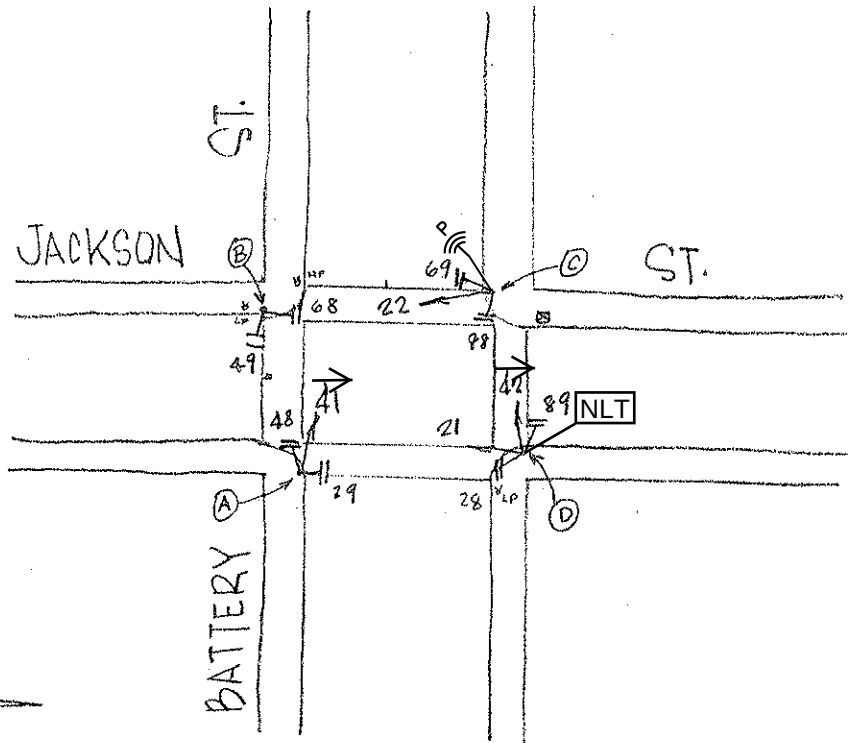
Add LT Blank-out Sign, Changed 41 & 42 to 4S12"GLA, Upgrade 22 to 12-inch, per SRC 2022-205 - P.Panyam, W.Lee
Per field: signal 21 is 12-inch.

Add preempt radio on Pole C, per SRC 2022-205 - S.Alexander, M.Velasco
